ITEM: 6.7	REPORT SUMMARY MINOR VARIANCE APPLICATION FILE NUMBER A127/24
------------------	------------------------------------------------------------------------------

MINOR VARIANCE APPLICATION FILE NUMBER A127/24

CITY WARD #:	5
APPLICANT:	Copper Kirby Developments Limited
AGENT:	Steven McIntyre (Malone Given Parsons Limited.)
PROPERTY:	11363 Highway 27, Vaughan
ZONING DESIGNATION:	See below.
VAUGHAN OFFICIAL PLAN (2010) DESIGNATION:	Vaughan Official Plan 2010 ("VOP 2010"): "Low-Rise Residential" by Volume 2, Section 13.47 - 11363 Regional Road 27 (OPA #47)
RELATED DEVELOPMENT APPLICATIONS:	OP.17.007, 19T-22V006 & Z.22.029
PURPOSE OF APPLICATION:	Relief from the Zoning By-law is being requested to permit a proposed retaining wall.

GRADING PLAN 2

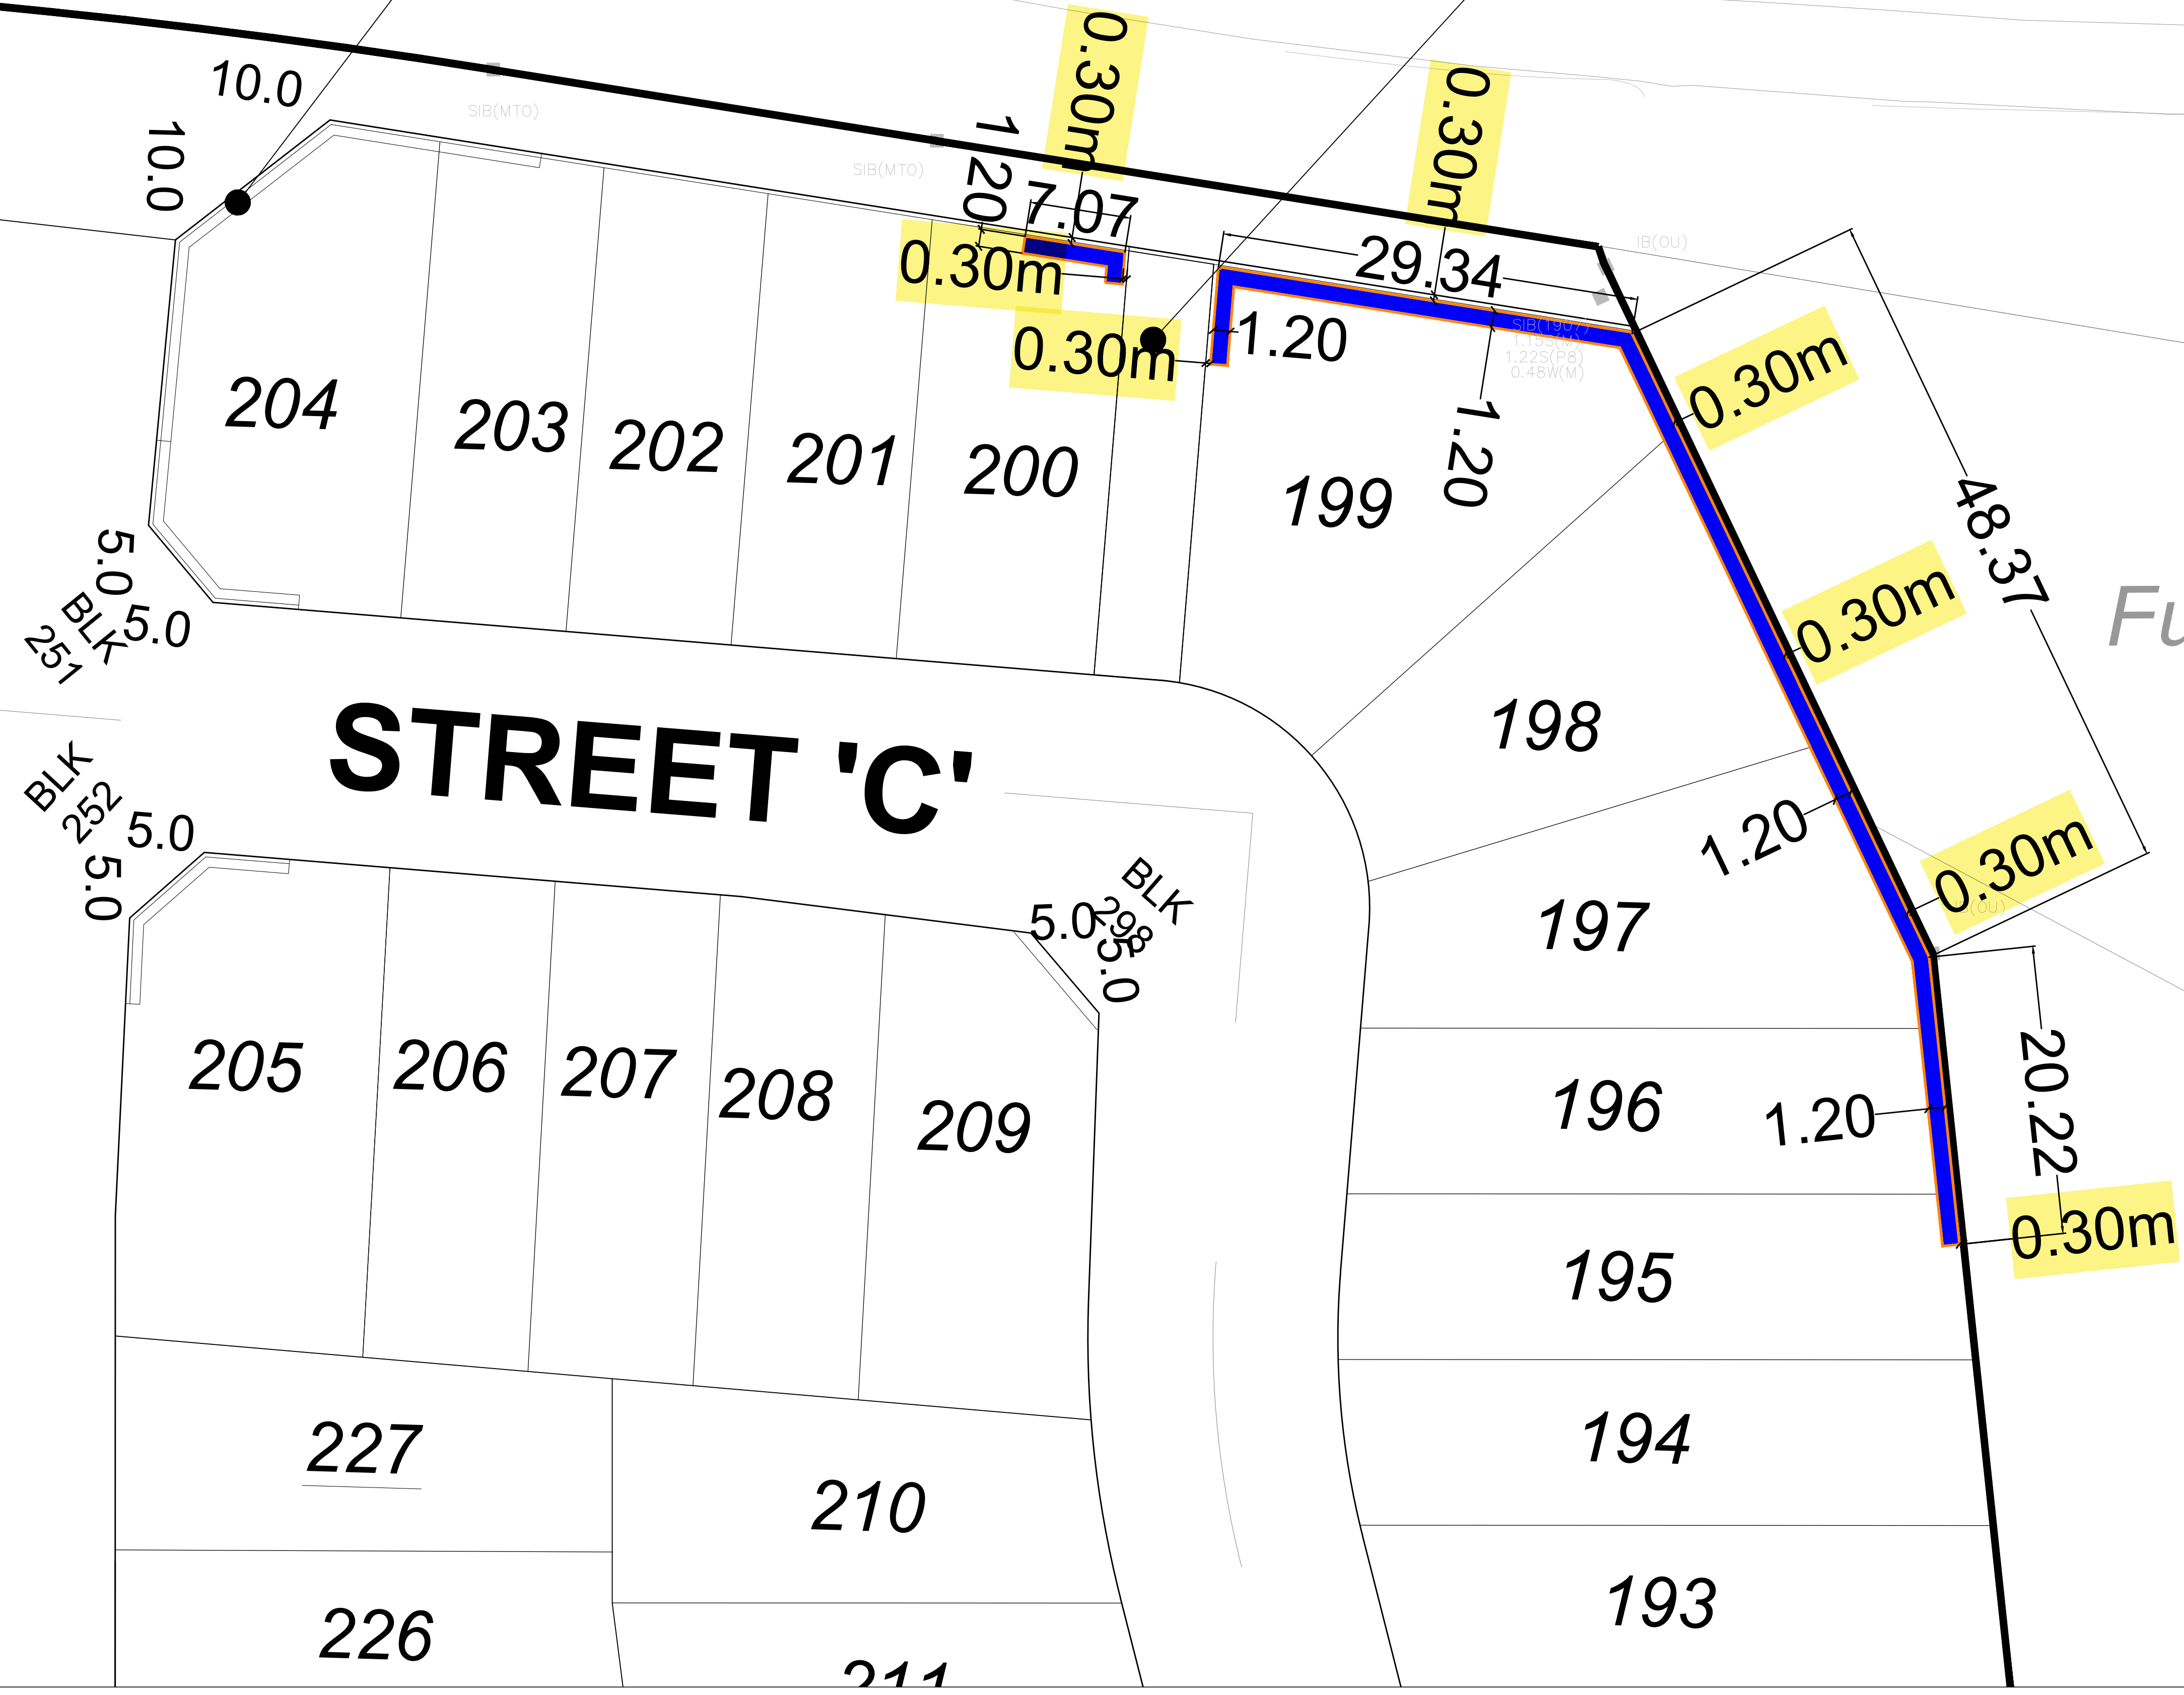
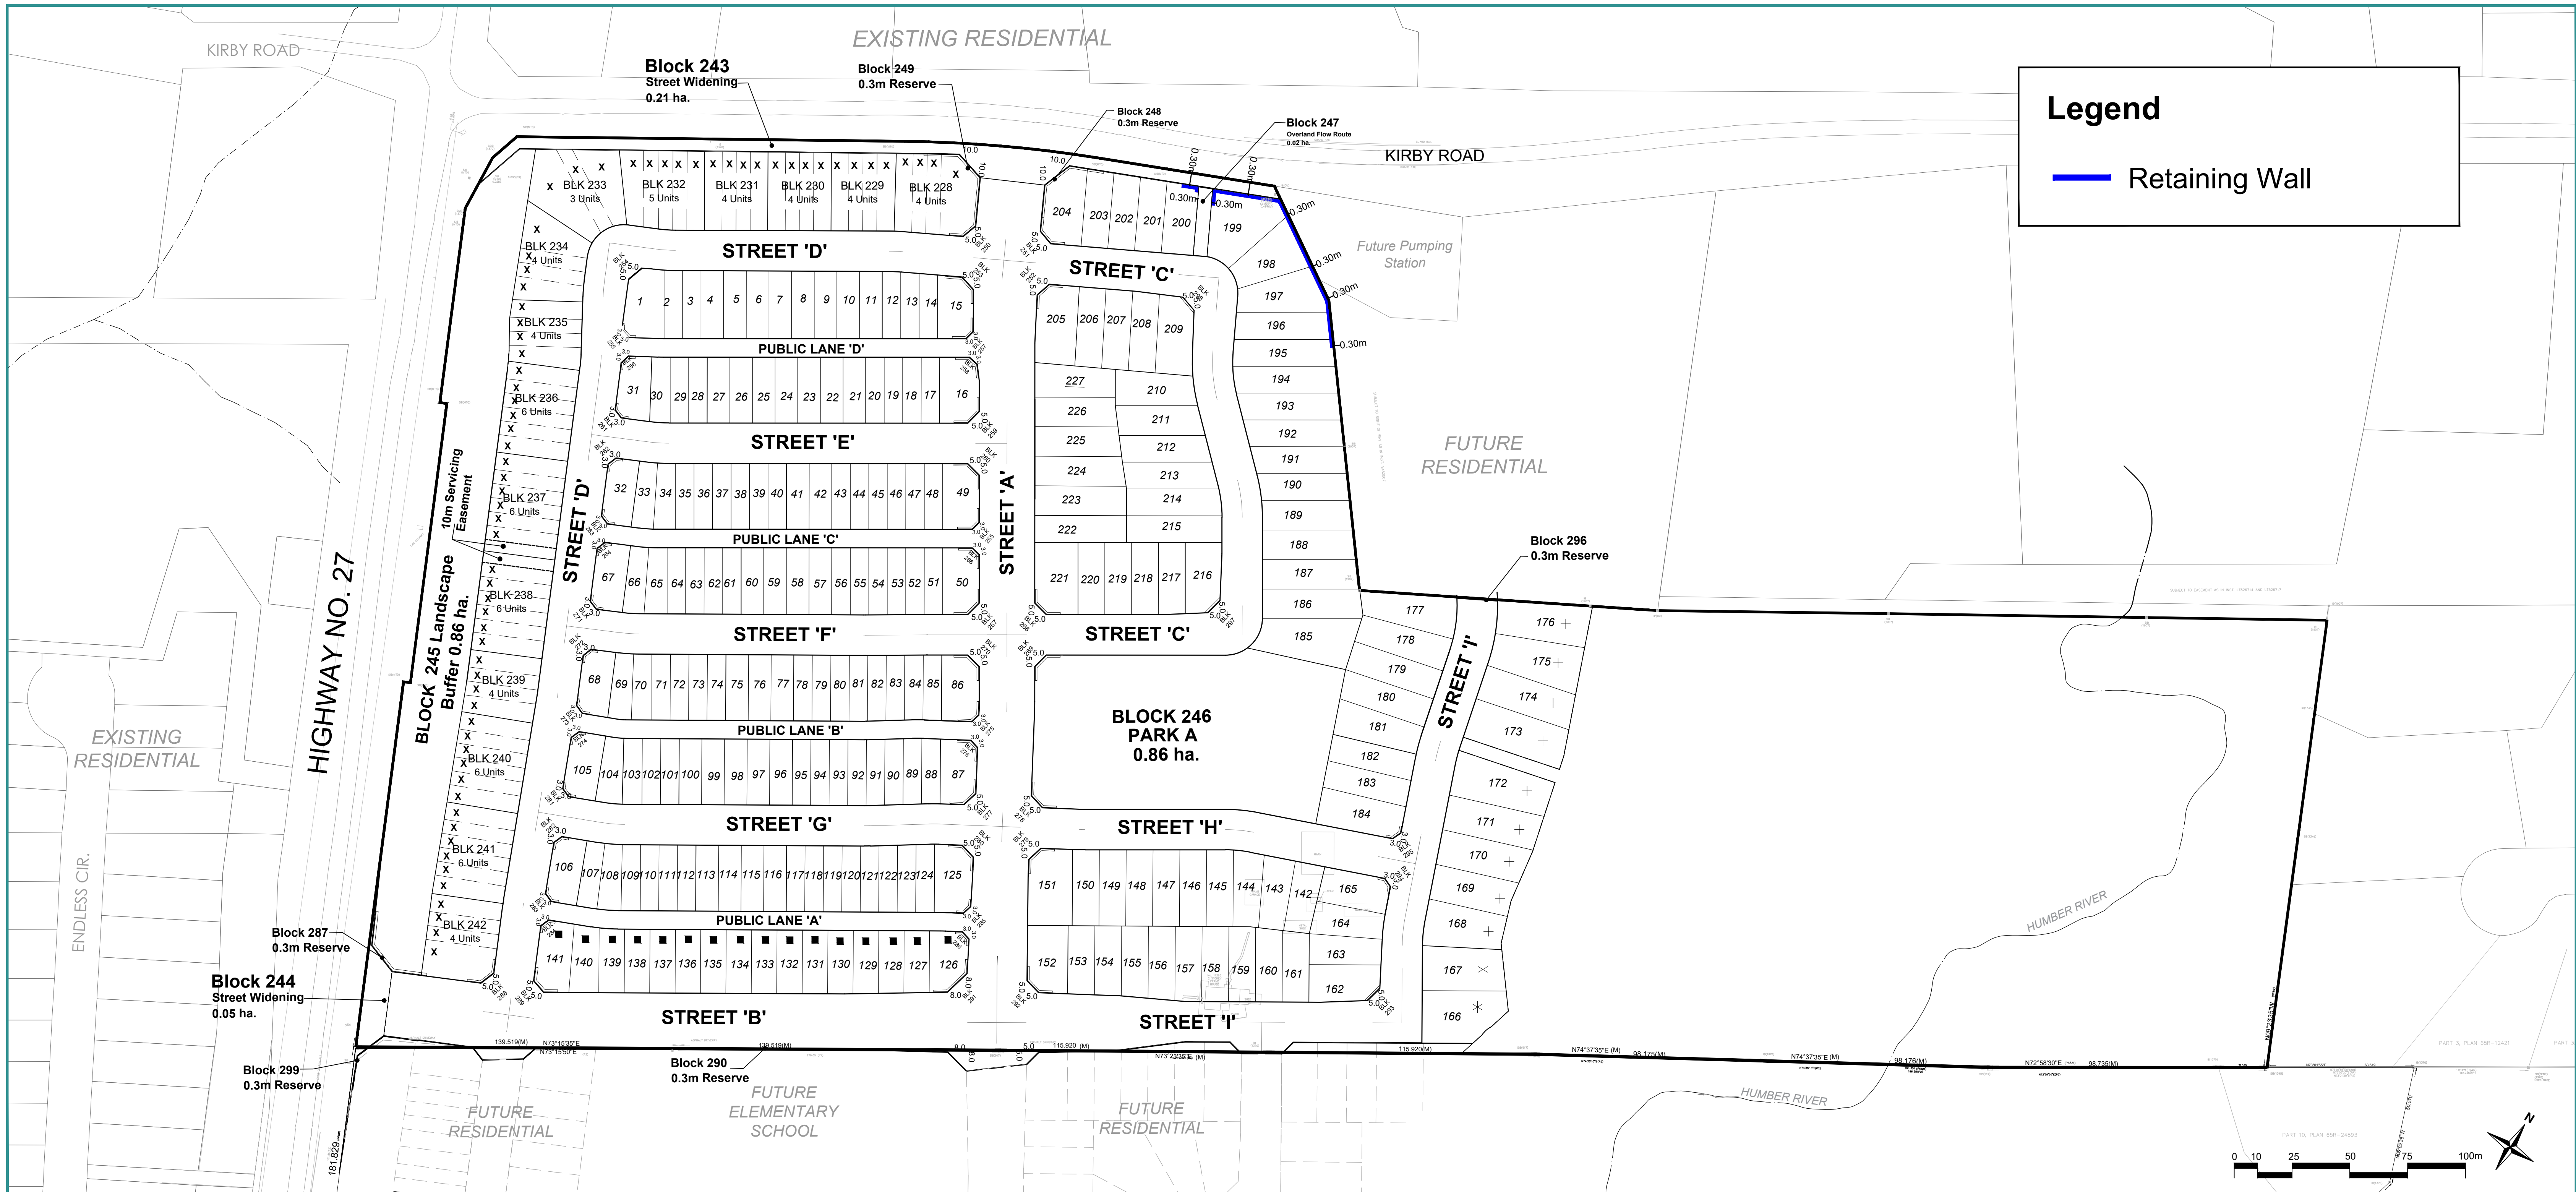
Development Engineering has reviewed application for the construction of the retaining wall and its encroachment to the temporary access to the existing dwelling where the sanitary pump station is proposed to be located. It is important that the timing of construction of the retaining wall is key so that it will not affect the disruption of the temporary access driveway. The Development Engineering Department does not object to the Minor Variance application A127/24, subject to the following condition(s):

Development Engineering Recommended Conditions of Approval:	The retaining wall shall not be constructed until an alternative access to the existing house has been provided, to the satisfaction of the City. Once the alternate access road is completed, the Owner/Applicant must submit proof, i.e. as-built drawings, inspection report, verifying that the road has been constructed.
--------------------------------------------------------------------	--------------------------------------------------------------------------------------------------------------------------------------------------------------------------------------------------------------------------------------------------------------------------------------------------------------------------------
